Z-71
(2017)

PROJECT NAME:
**THE OVERLOOK AT
HILLTOP DRIVE**
COBB COUNTY, GEORGIA

PETITION NO: Z-71

ZONING COMMENTS:

Z.100

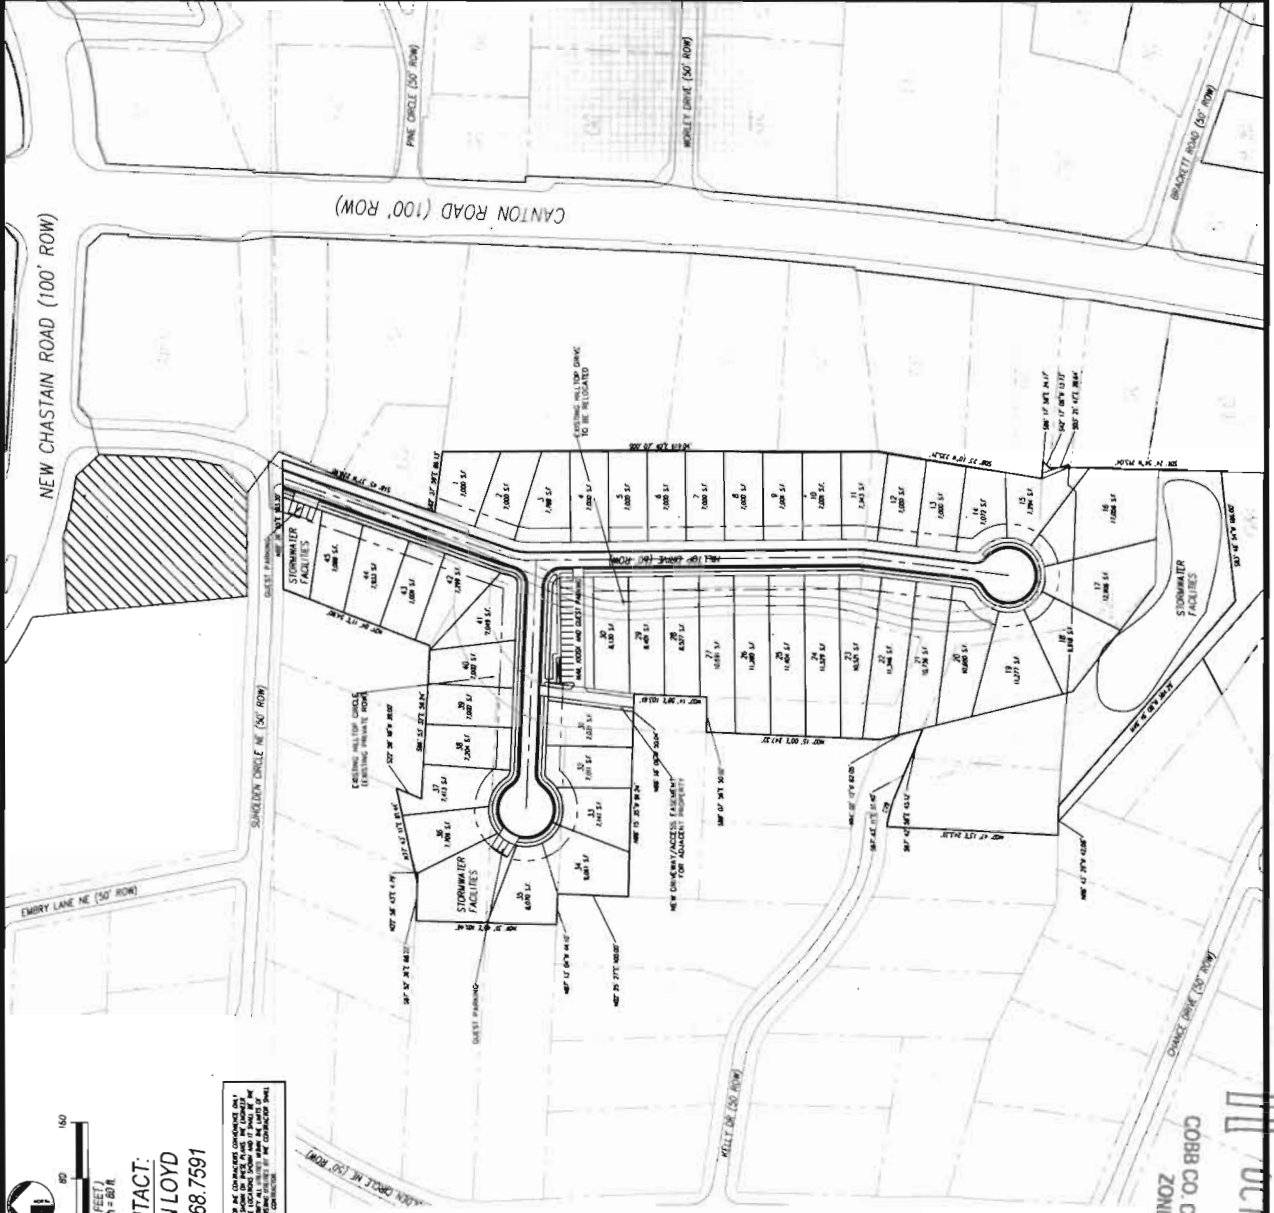
The applicant’s plan envisages the realignment of Hilltop Drive as well as the relocation and abandonment of portions of Hilltop Circle. As a result of this relocation and abandonment of portions of Hilltop Circle and due to the exclusion of the parcel at 3229 Hilltop Circle, a concurrent variance should be considered for this property whether as part of this application or as a later variance application due to that parcel no longer having the Code-required 75 feet of public road frontage.

Otherwise, the applicant’s plan demonstrates the need for the following concurrent variances:

1. Waiver of the minimum lot size to allow three (3) lots under 7,000 square feet in size (lot 37 – 6,892, 38 – 6,867, 39 – 6,859);
2. Waive the minimum lot width at the front setback line as well as required public road frontage from the required 75 feet for exterior lots to approximately to as low as 54 feet for lots 43, 44, and 45;
3. Waive the rear setbacks from the required 40 feet for exterior lots to 20 feet; and
4. Waive the front setbacks from the required 25 feet for interior lots to 20 feet.

Though the applicant’s proposal does not indicate the Code-required 10-foot landscape buffer that should be placed along the proposed community’s western edge where it abuts more restrictive residential zoning, a variance is not appropriate as there is ample room to provide such buffering if required as part of a Board of Commissioners approval.
